TX-7

BULLETIN NO. E-344

Use of Tantalum Capacitor in Back-up Circuit on DM Circuit Board

# SERVICE NEWS

- \* Hardware change (Load Circuit Filter Characteristics change).

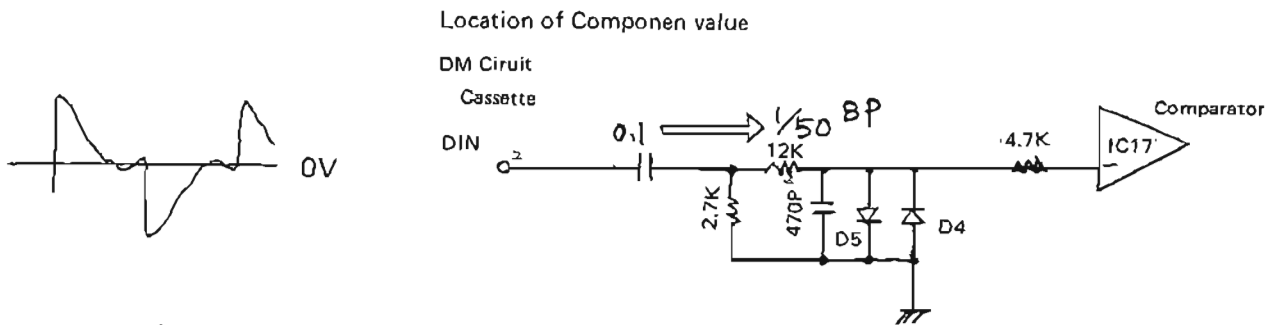
In some cassette tape recorders, when saving or loading, input signals are excessively differentiated and input signal wave-forms become as shown in the below figure. Hence these wave-forms reach the comparator threshold and errors occur. To prevent this trouble at most, the capacitance value will be changed and thus cut-off frequency will lower.

Part Name	Part No.	Version No.
System ROM	OLD	iN011110
	NEW	iN011120
Bipolar Capacitor 1 $\mu$ /50V	FM116100

When any above symptom is found out, change System ROMs and capacitors.

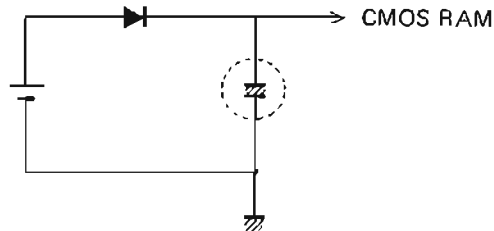
- *Purpose:*  
For reduction of leaking electric current.
- *Contents:*  
The mini-sized chemical capacitor, which is used in RAM back-up circuit driven by a lithium battery, will be replaced by a tantalum capacitor in order to reduce the leakage.

Part Name	Part No.
Tantalum Capacitor 10 $\mu$ /16V	FP337100
